Access Compliance Report

Public Rights-of-Way

(Curb Ramps)

Intersection ID: 29149	Main Street: STONEY_GARDEN_DR	Cross Street: CREEK_BREEZE_RD	Location: NE
ADA ID: 097F1A8691D0	Ramp Type: BlendTrans1	Initial Pass/Fail: Pass	Overall Compliance: No
Severity Score: 25.25			
Codes/Mitigation Info/Possible Solution		Field Measurements/Component Compliance

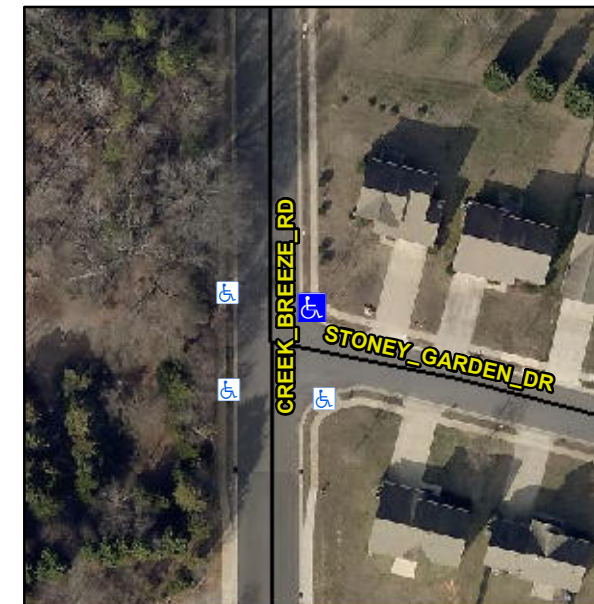
Remove & Replace Curb Ramp With Two New Directional Ramps or Equivalent. Remove & Replace Gutter.

CRACK RT FL

R304.5.1, R304.2.1, R304.2.2-Perp, R304.3.2-Para, R304.5.3, R305.2, R302.7.2, R304.5.4
